ASSESSMENT REPORT

SHERATON FOUR POINTS, 161 SUSSEX STREET, SYDNEY SSD 4972 MOD 4

This report provides an assessment of an application seeking approval to modify State Significant Development (SSD 4972) for the redevelopment of the Four Points by Sheraton Hotel.

Figure 3: Proposed eastern elevation (changes in red)

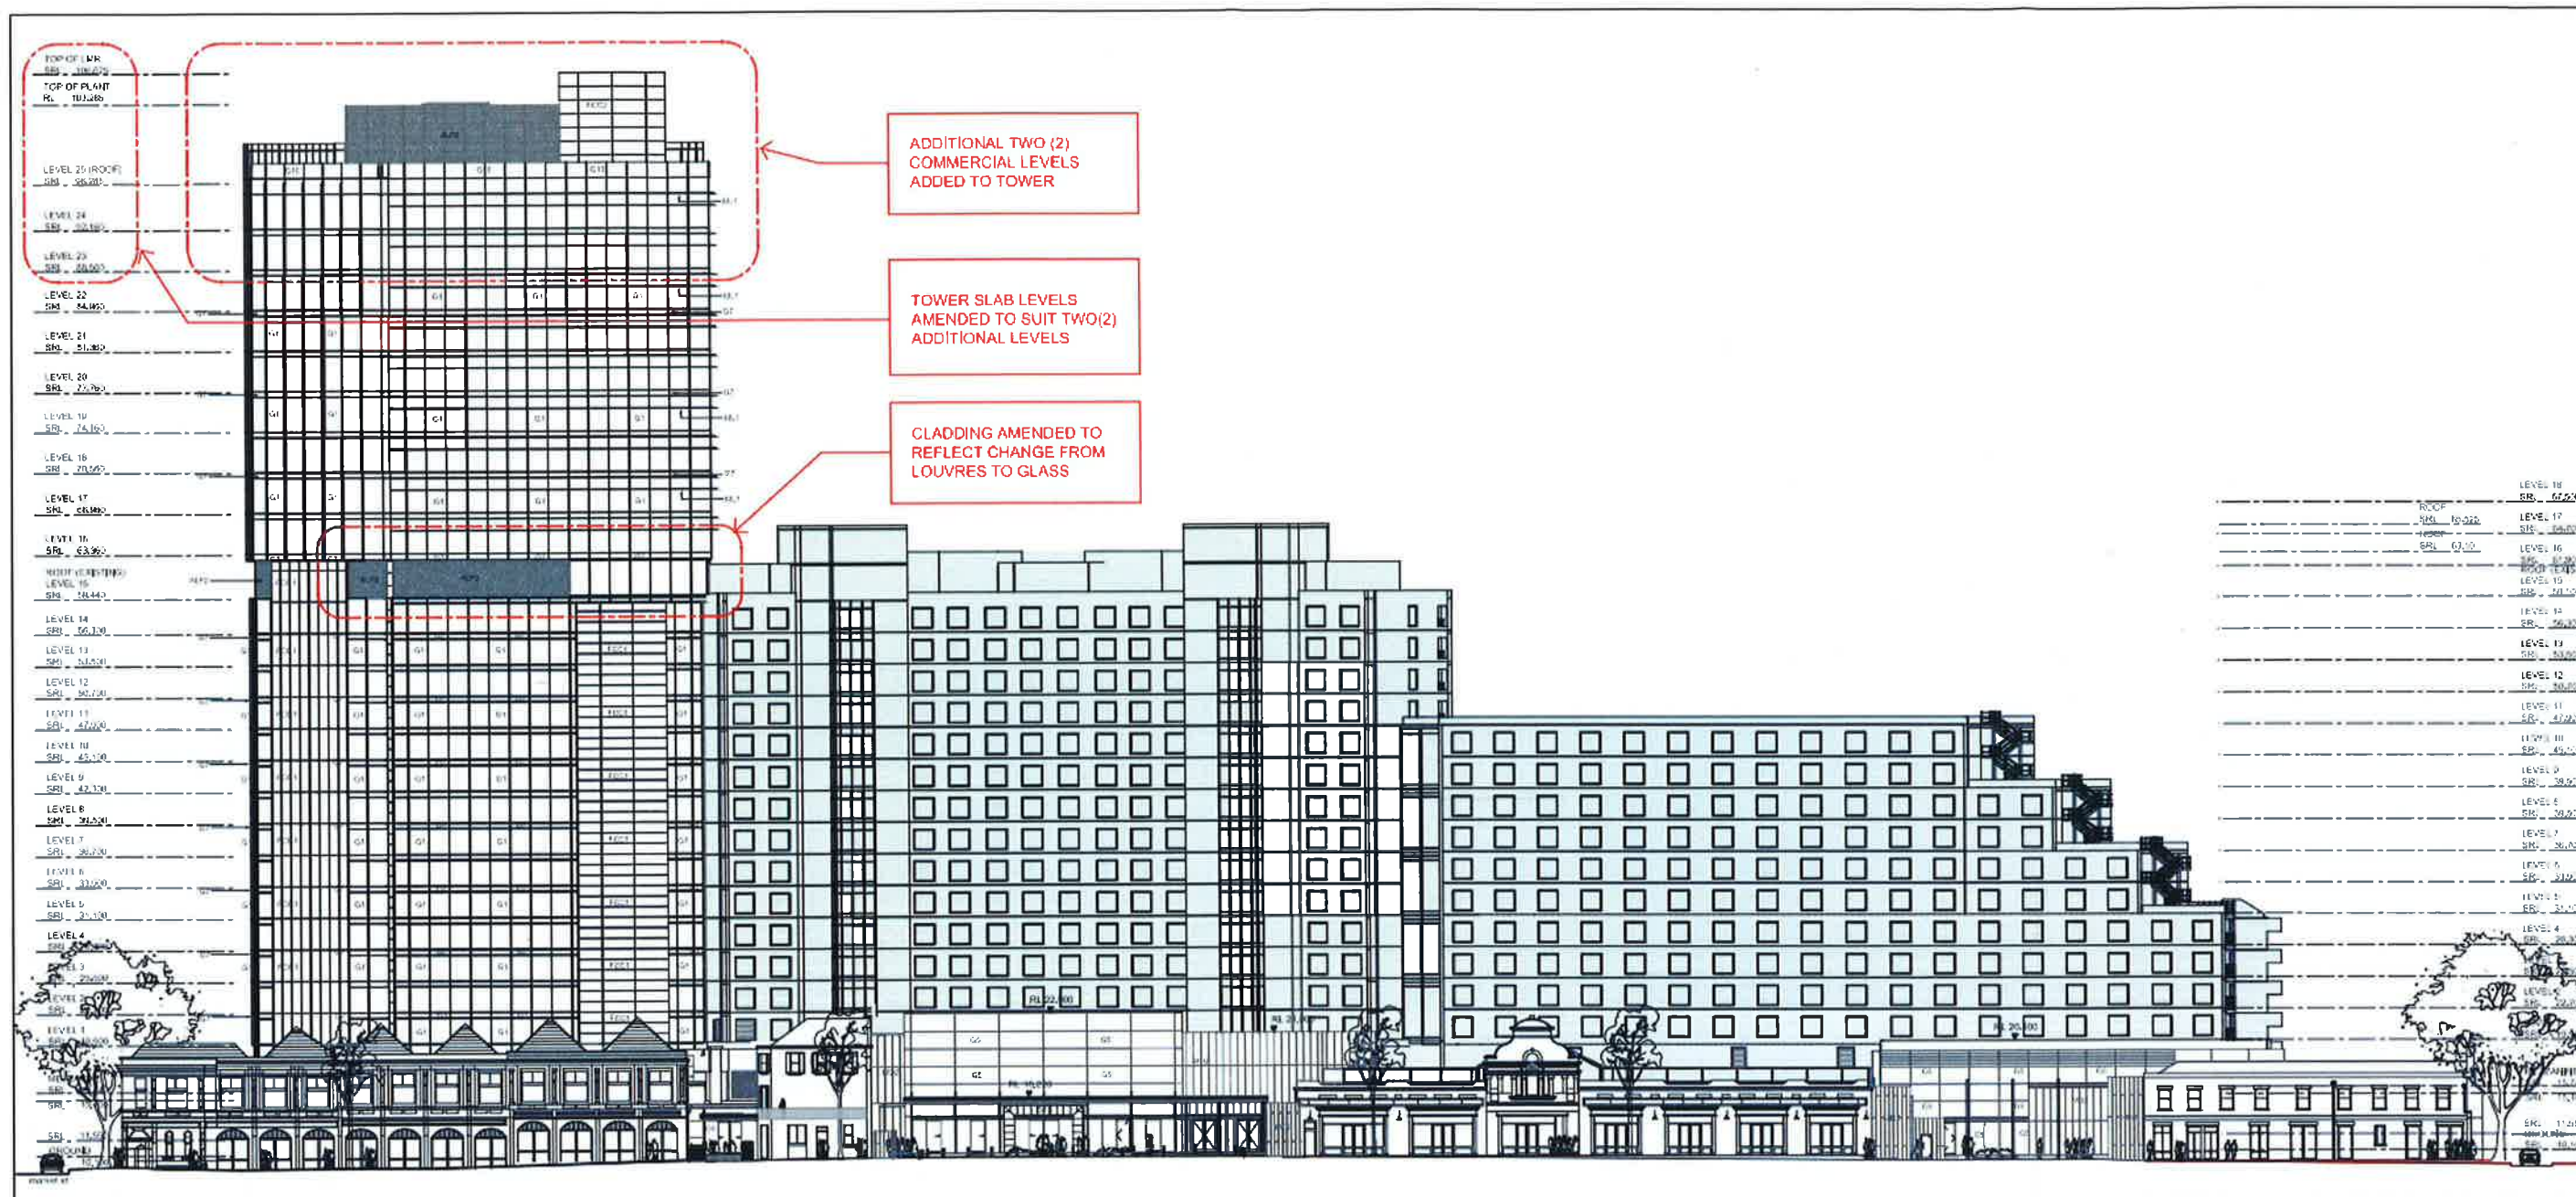
The application seeks approval for a minor change to part of the façade cladding at Level 15 from louvres to glass. However, as the change affects only a small part of the northern and eastern elevations, which are not readily apparent (being partially obscured by the adjoining hotel building) the change is of no material consequence. The overall appearance of the building therefore remains the same, other than the increase in height.

Figure 5: Proposed tower within city skyline. (Source: Applicant's Visual Impact Assessment)

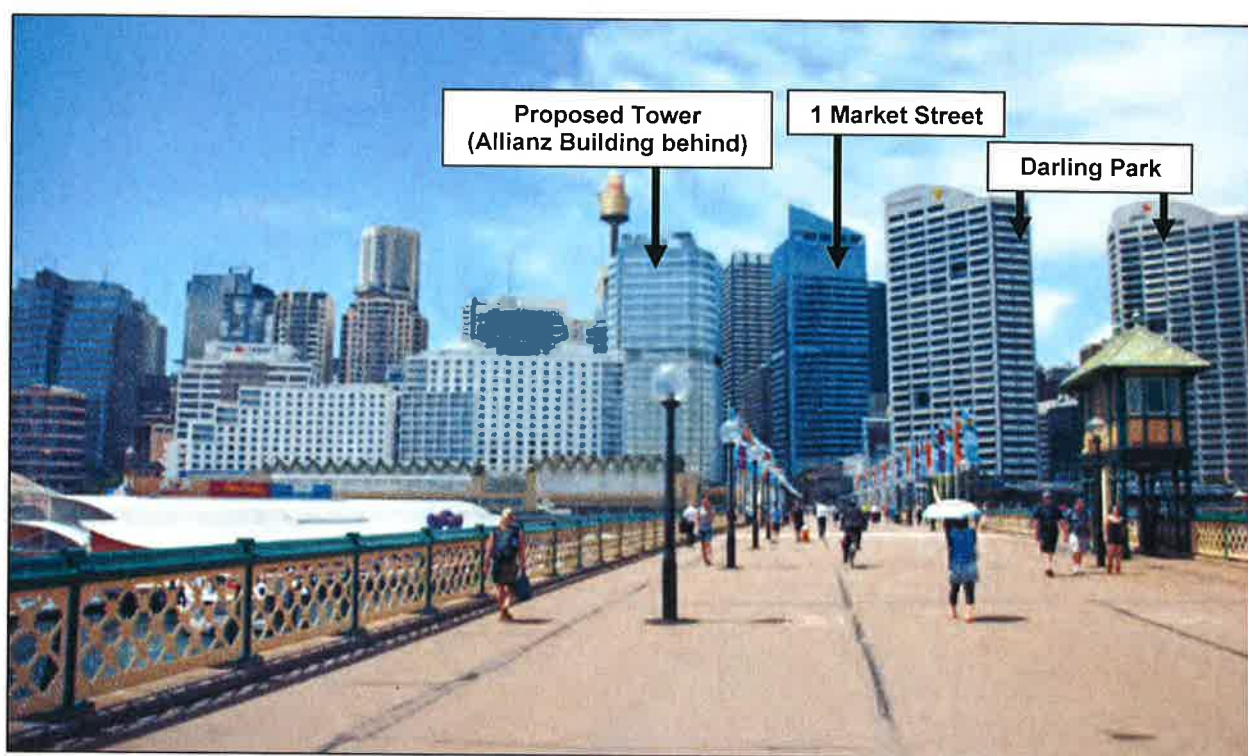
The visual impact of the proposed increase in height is most apparent when viewed from the west of the site. **Figure 5** below illustrates the proposed tower as viewed from within Darling Harbour. From this vantage point, the building height can be clearly read in the context of the surrounding development, being part of an existing line of development forming the CBD edge. At other points in close proximity to the site, the change in height would not be as readily perceptible from a pedestrian level.

The proposed height increase to RL 106.025 is considered to still fit comfortably within the range of existing building heights immediately surrounding the development and would comfortably blend in with existing development in the city skyline, as can be seen below (**Figure 5**).

On this basis, the Department is satisfied that the proposed increase in height is acceptable.

Figure 7: Views from Level 15 of the Berkeley as approved (left) and as proposed (right)

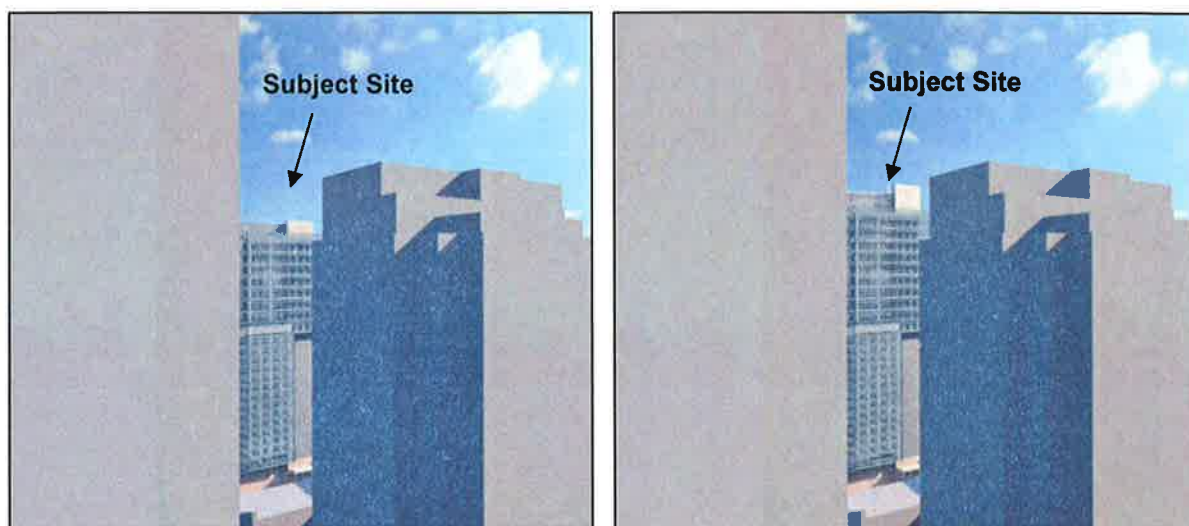
As seen in **Figure 7**, the proposed additional two levels would not result in any view impacts to dwellings at 25 Market Street, as all views from this building are already obstructed by the approved building. The proposed additional two levels would not be highly perceptible within the context of surrounding buildings which appear taller in height.

Figure 8: Views from Level 32 of the Astoria as approved (left) and as proposed (right)

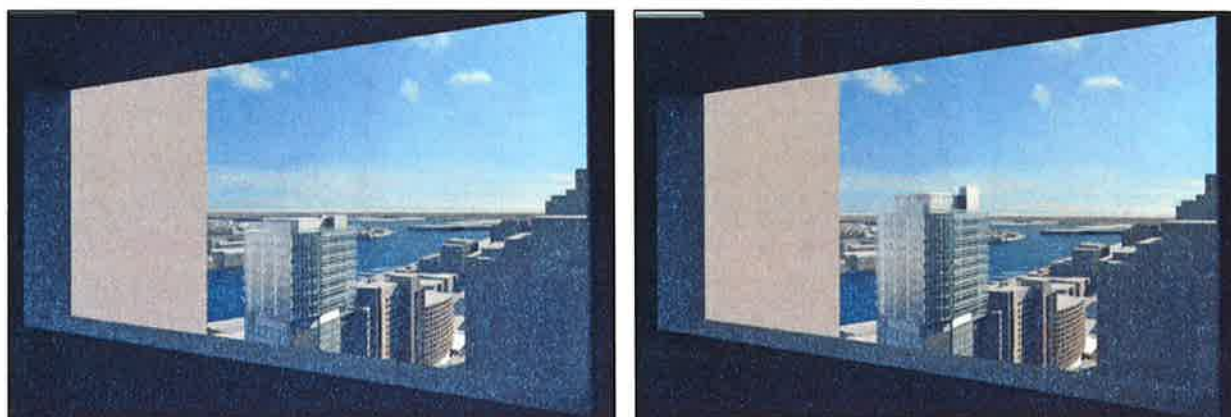
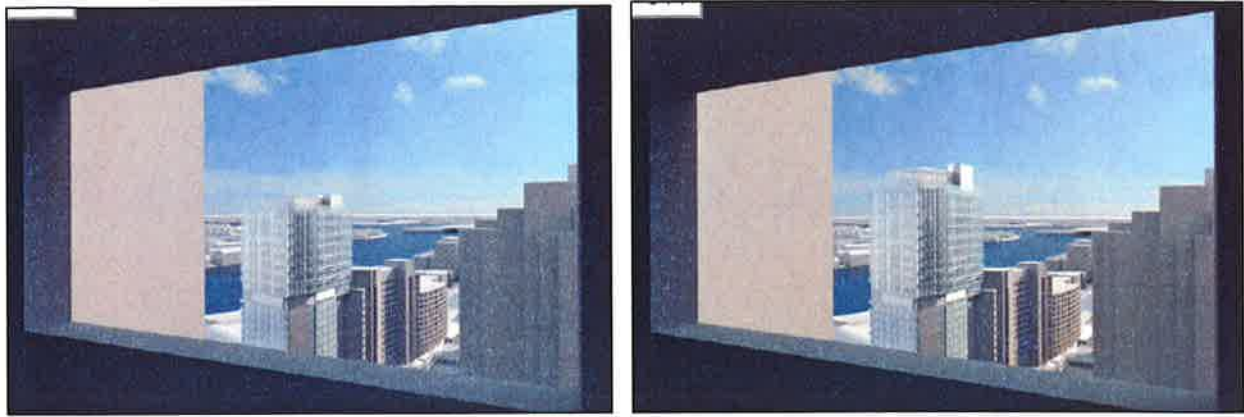
As seen in **Figures 8 and 9**, the proposed two additional levels would impact on views of the horizon line from the top most level of the Astoria Tower (Level 32). From all other levels, these views are already obstructed and view impacts would be limited to some obstruction of the sky only.

The Department considers in that in the context of this high density CBD location, these view loss impacts are minor and acceptable, particularly given that the proposal does not result in any additional impacts on any retained iconic views of the water, the Harbour or landscape features, which provide the primary source of amenity from views.

The Department is therefore satisfied that the proposed modification would not result in any unacceptable view sharing impacts. Any impacts to residential views are minor, generally only impacting on some existing views of the sky, and not impacting on any retained iconic, water, or district views.

Figure 10: Location of carpark site next to Astoria which may obstruct views in the future

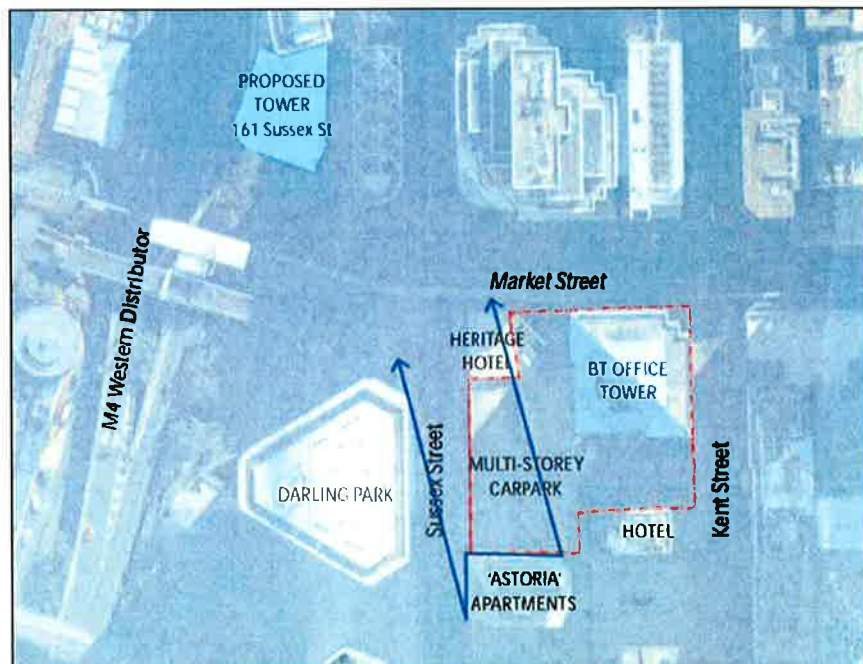
Further, in its assessment of the original application, the Department noted that these primary views from the Astoria building are achieved across a side (northern) boundary and over the top of the adjoining site which is currently developed well below the maximum permitted floor space and height (**Figure 10**). A binding covenant exists on all contracts for units within the Astoria tower which permits Council to seal all windows on the northern boundary, should that site be developed in the future. Therefore there can be no reasonable expectation of view retention from the units within the Astoria tower in the long term.

Figure 11: Aerial view of subject site and areas to the south affected by shadowing

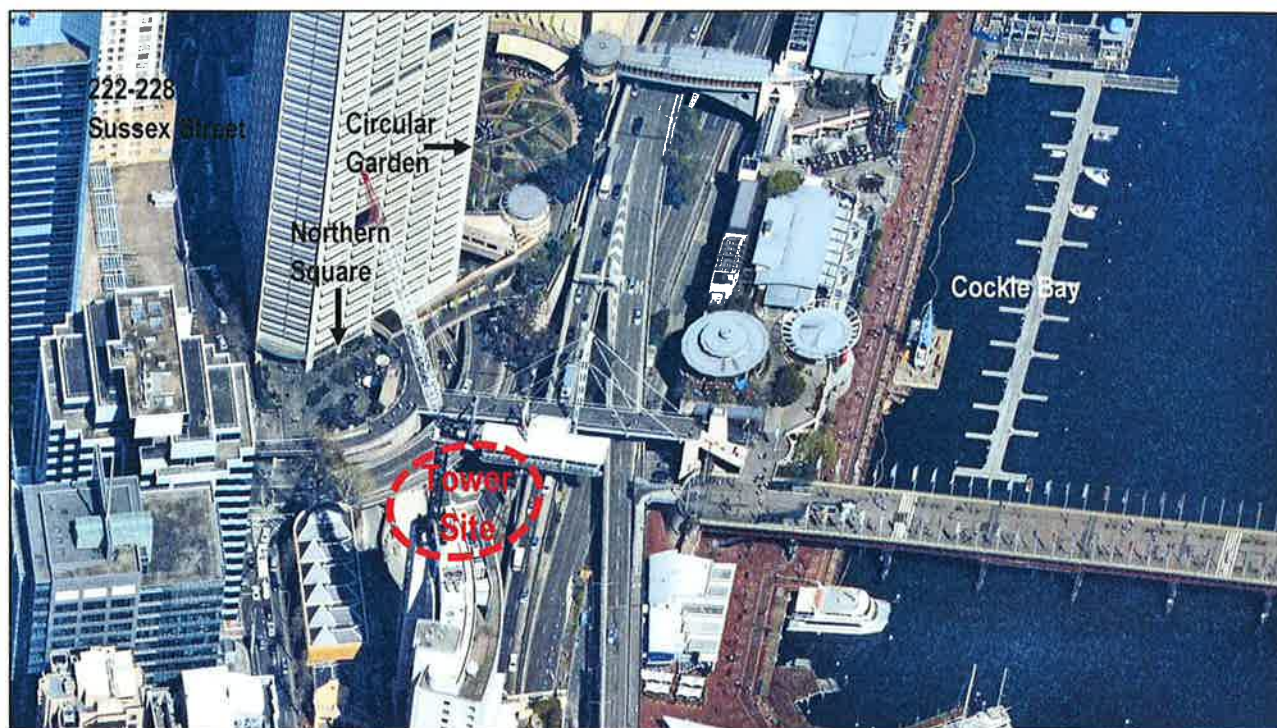
The shadow diagrams also indicate that the proposal would have some additional shadowing impacts for nearby public domain areas including the Circular Garden and Northern Square within the Darling Park Site, and a small section of the waterfront area and waterway of Cockle Bay (locations shown in **Figure 11**). Noting there are no specific requirements for the retention of solar access to public domain areas which apply to the proposed development, the Department has considered the impact of the proposed modification to these areas on its merits.

At the Circular Garden and Cockle Bay waterfront, the additional overshadowing of the public domain is for a relatively short period of time at mid-winter and limited to a small area. Overall, good levels of solar access, (in excess of three hours to the majority of the Circular Garden and the entire waterfront area) are retained to these areas at mid-winter, despite the additional overshadowing.

However, the Northern Square within the Darling Park site is already significantly overshadowed by the proposed tower, with limited solar access at mid-winter. While the additional two levels would not result in further impacts to the square at mid-winter due to the length of shadows at this time of year, at other times of the year the additional height would increase the extent of overshadowing on the square. For example, at the equinox, the proposal would result in additional shadowing to parts of the square between 12.00 midday and 3.00 pm. Despite the additional shadowing impacts, the Department is satisfied that the extent of shadowing is acceptable in this case as:

- even at the worst affected time during the equinox, at least 50% of the square receives solar access;
- the square is located immediately to the south of the site and it is unreasonable to expect that the square would not be overshadowed as a result of the proposal in this CBD location; and
- the square operates more as a pedestrian circulation area and does not provide the same functions or levels of amenity as an open space area such as a park (as seen in **Figure 11**).

Overall, the Department is satisfied the shadowing impacts of the proposed modification are minor and acceptable, given:
